Natural Resources  
Canada

**Re: Natural Resources Canada's Closing Remark and Technical Memorandum – New Prosperity Federal Review Panel**

### **Natural Resources Canada's Technical Memorandum – New Prosperity Federal Review Panel**

Figure 1: Cut-away view of NRCan's 3D numerical model of TSF seepage showing impounded tailings (grey) and PAG waste rock (red) and underlying geological formations as described in CEAR #587.

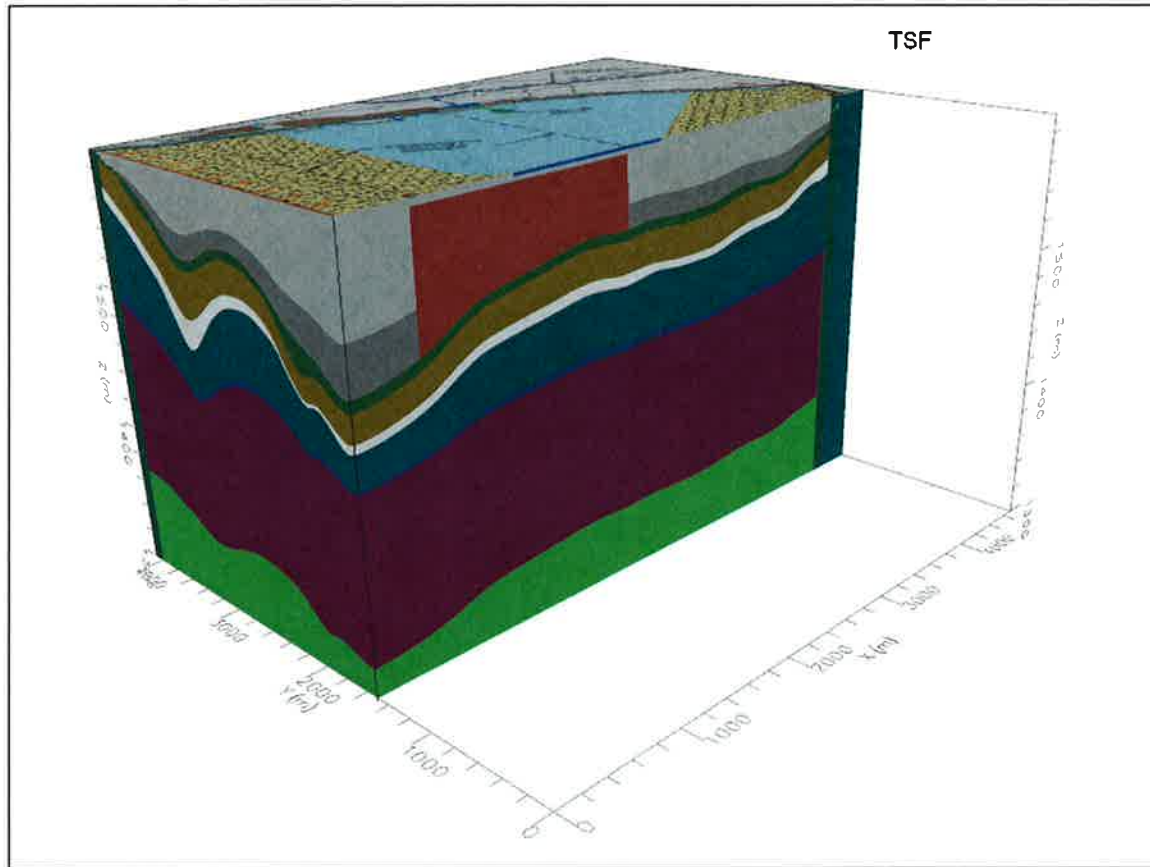
NRCan's estimates of post-closure seepage rates from the TSF (CEAR #587) were based on a three-dimensional (3D) numerical groundwater flow model spatially restricted to the impoundment and underlying geological formations including the shallow and deep groundwater zones (Figure 1). The model was not calibrated to head observations. However, the model was "nested" within the regional groundwater flow system using "General-Head" boundary conditions

Figure 2: Representation of the proponent's 2D cross-sectional numerical model. From Figure B.2, Appendix B, Appendix 2.2.4-D.

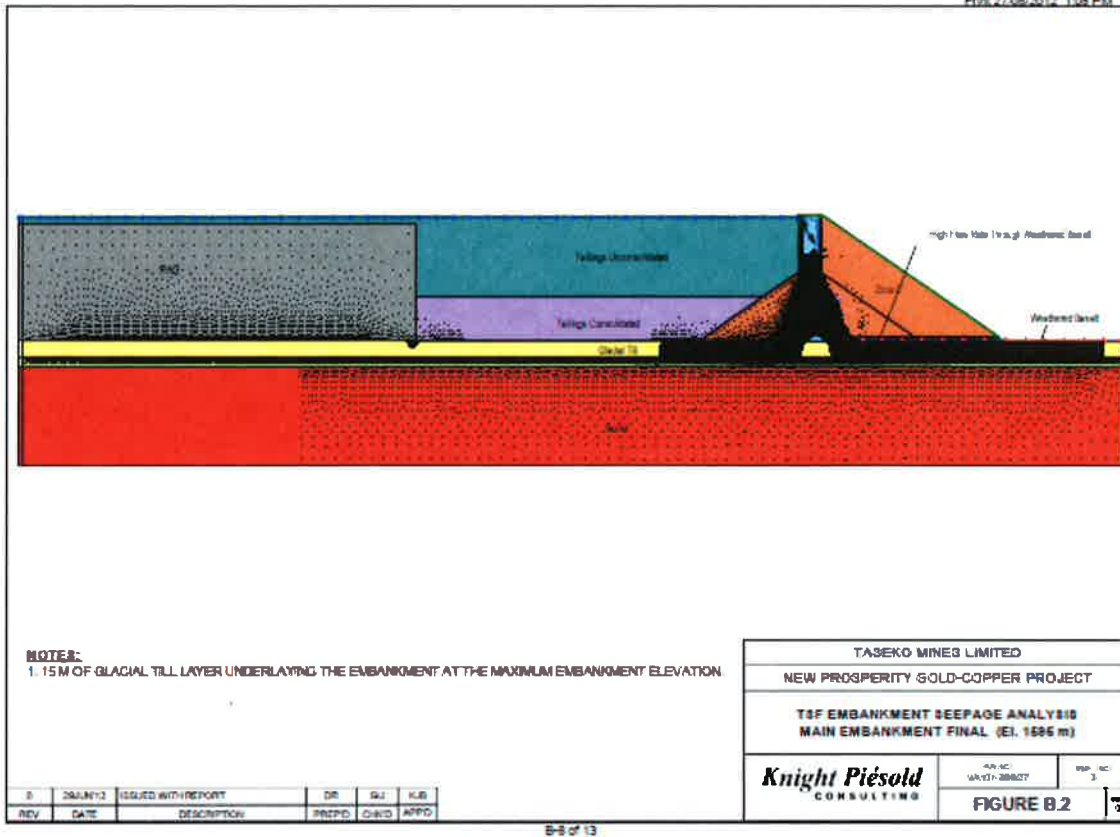
The primary TSF seepage estimates carried forward by the proponent as inputs to site water balance and water quality modeling were based on a two-dimensional (2D) cross-section numerical modeling approach (Appendix 2.2.4-D). This approach involved estimating seepage rates over a number of vertical sections through the main, south and west embankments of the TSF. An overall seepage rate was then obtained by summing seepage contributions from each modeled section prorated according to their respective representative embankment lengths. While not incorrect, such an approach should be considered inferior to a fully 3D approach for seepage prediction purposes. The spatial domains of the proponent's sectional models included a partial representation of the TSF and a representation of underlying geological formations limited to the shallow groundwater zone (Figure 2). Because of this, the proponent's modeling approach could not be used to calculate estimates of seepage through the entire base of the TSF that could be compared to NRCan's. The proponent's approach is suitable only for estimating seepage fluxes in the shallow groundwater zone beneath the TSF embankments (as shown in Figure 2). However, NRCan's 3D modeling results also suggested a significant seepage flux from the shallow to the deep groundwater zone that is precluded by the proponent's assumption of an impermeable boundary below the lower basalt sequence. Like NRCan's model, the proponent's 2D model was not calibrated to head observations. However, unlike NRCan's model, the proponent's 2D model was not "nested" within the regional groundwater flow system. Boundary conditions on the sides and base of the proponent's model of the TSF are purely generic. Because of this, the proponent's model does not account for groundwater interactions with the surrounding region beyond the TSF. Normally, this would be viewed as a limitation of the proponent's 2D modeling approach compared to NRCan's which does allow for such interactions through the use of appropriate boundary conditions.

The proponent has asserted that seepage rate estimates from NRCan's 3D model and Taseko's 2D model are not materially different, being within a factor of two. However, this opinion disregards the different modeling methodologies used by NRCan and Taseko, and the inherent limitations of the proponent's approach relative to NRCan's. It follows that seepage rate estimates from NRCan and the proponent should not be weighed equally by the Panel regardless of their actual values. In NRCan's opinion, the relatively small (factor of two) difference between NRCan and Taseko 2D estimates is fortuitous.
